COMMITTEE OF ADJUSTMENT

NOTICE OF PUBLIC HEARING

APPLICATION NUMBER: FL/B-21:44

SUBJECT PROPERTY: 198 Victoria St., Flamborough

TPD-1

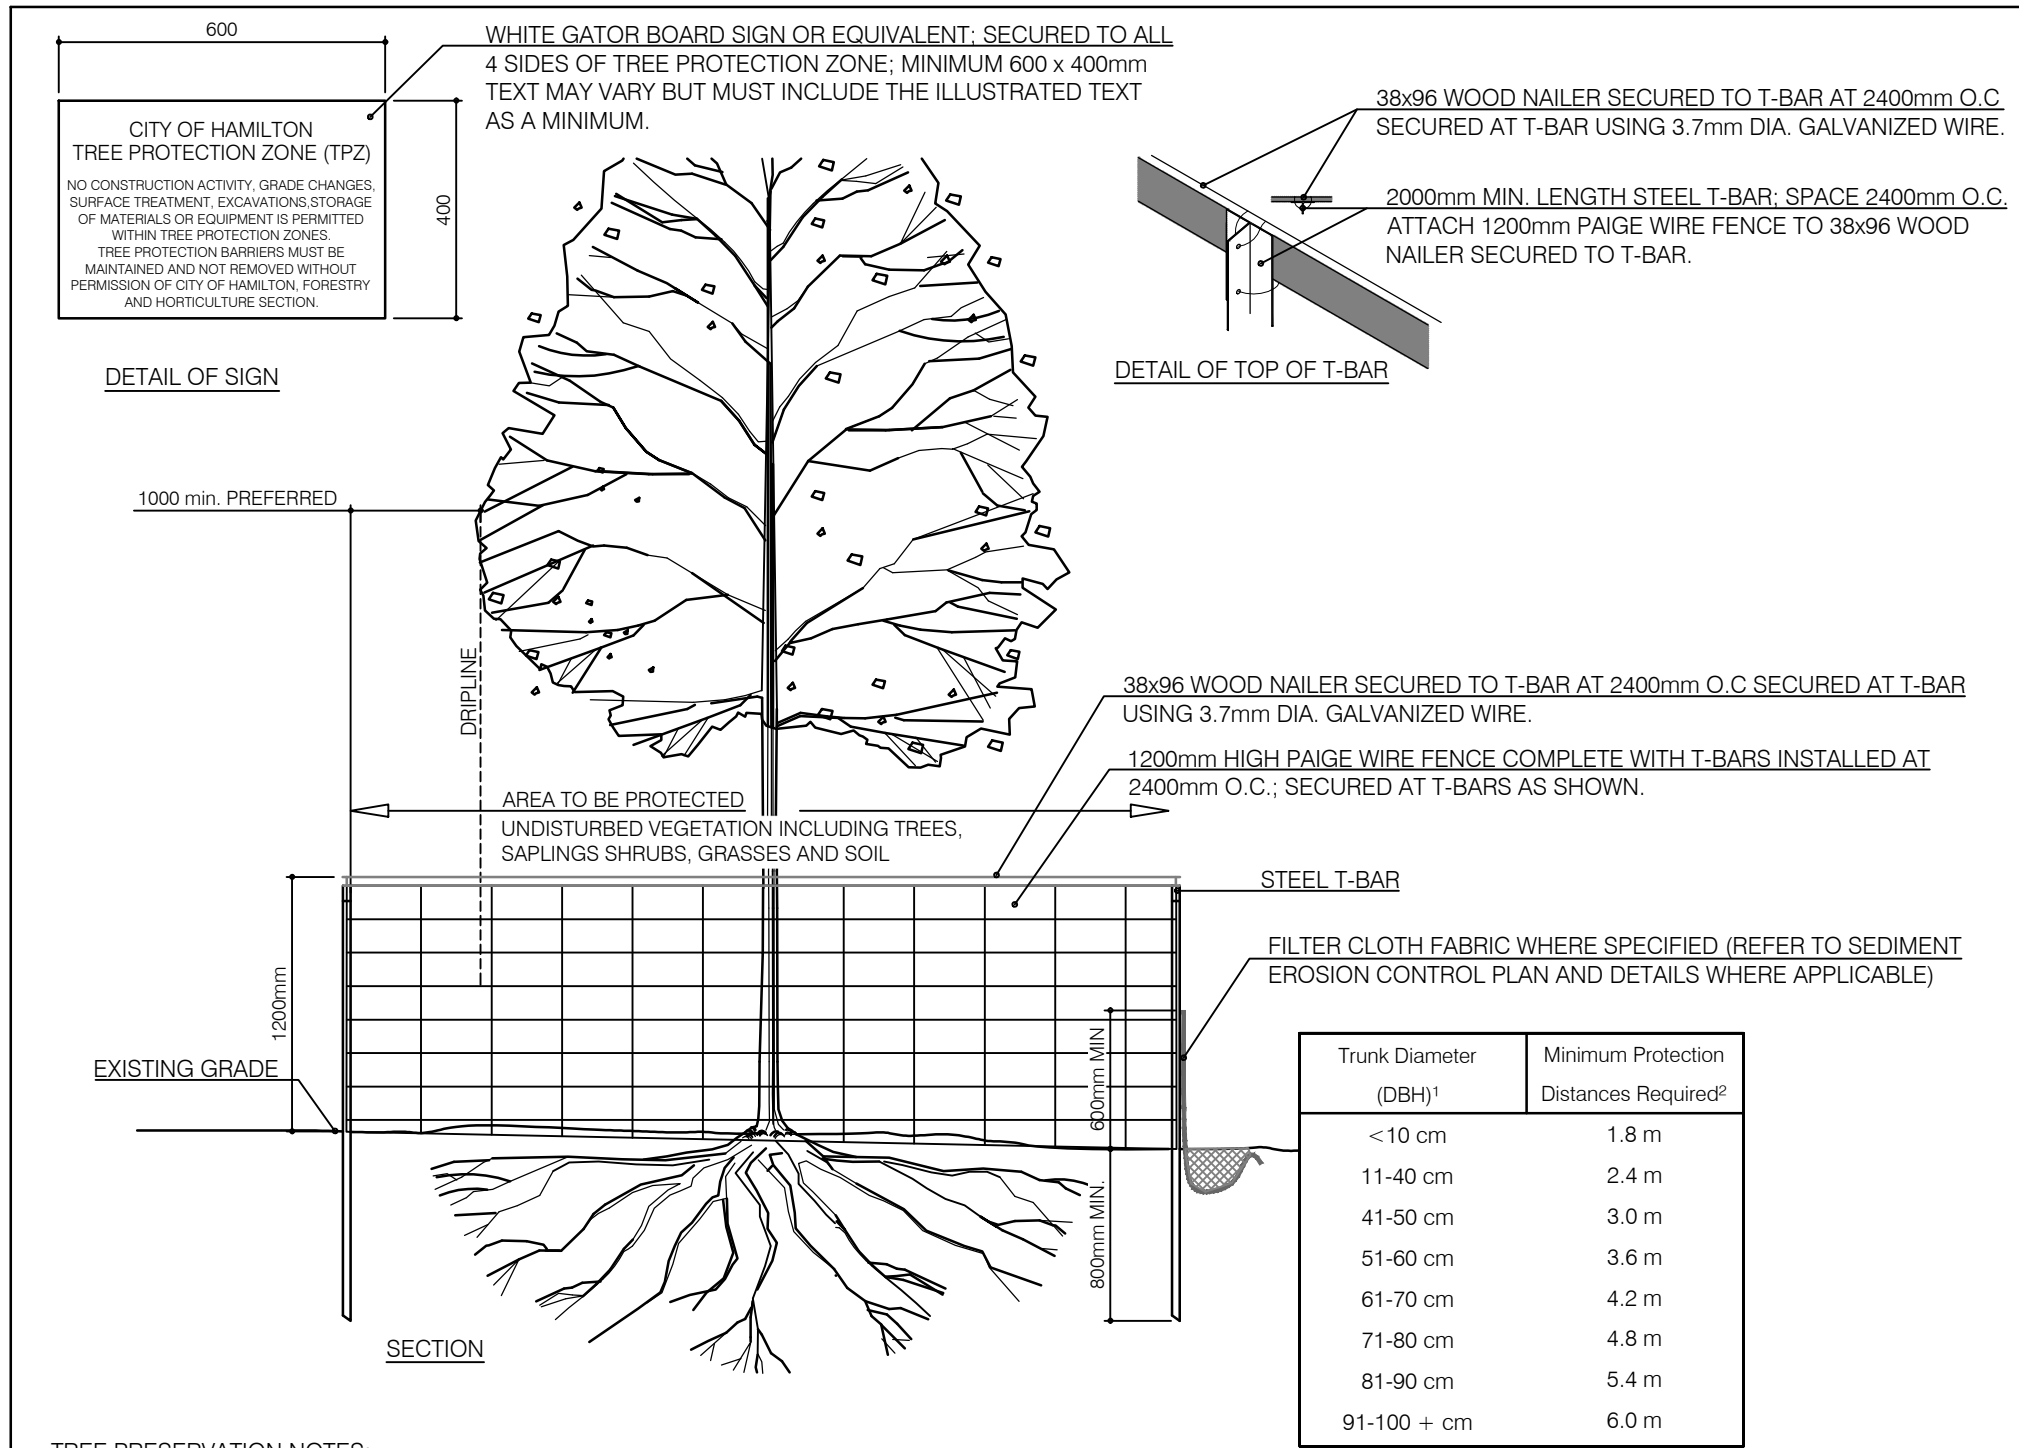
The severance and minor variance application will require a Tree Protection Plan (showing how trees will be protected on site) and a Landscape Plan (showing compensation plantings for any trees removed). There are many mature trees on site which will be impacted by construction and grading. Natural Heritage staff are particularly concerned because boundary trees, which are shared ownership with abutting properties (190 Victoria Street, and 47 Wellington Street), will likely be impacted by construction and grading. Under the Forestry Act, one co-owner cannot injure or remove a boundary tree without the other co-owner’s permission.

Before the severance and minor variances are approved, a Tree Protection Plan is recommended. The City should have some indication of the potential impacts to trees (on and off site) before it approves the severance.

To support this resubmission and address comments from stakeholders regarding potential tree impacts from the proposal, we have prepared a Tree Impact Study which includes a Tree Identification Table has been prepared and submitted. This Study includes conceptual dwelling footprint sizes and shapes on both Proposed Lot 1 and Proposed Lot 2. The intent is to show maximum dwelling footprints, based on a 25% maximum lot coverage, within the potential building envelopes created by the permitted dwelling setbacks. It also includes potential driveway widths and locations.

minimize tree impacts and removals. The plan provides potential tree protection fencing locations to show how areas of construction and disturbance can be limited within each site. Further, it confirms that existing trees that would need to be removed based on this concept are located solely on the subject lands. In our opinion, this adequately address comments from the Committee and stakeholders, and confirms that tree impacts are a minor and manageable issue. It also underscores that the proposal will maintain compatibility with the character of the neighbourhood by retaining most of the existing trees. For instance, based on this plan and these assumptions, approximately 76% of existing trees will be retained on site.

We note that the previous staff comments requested the submission of a Tree Protection Plan as a condition of approval. Given we have addressed this issue with our Tree Impact Study submission, we respectfully request that there be no conditions requiring further Tree Protection Plan submissions attached to the decision.
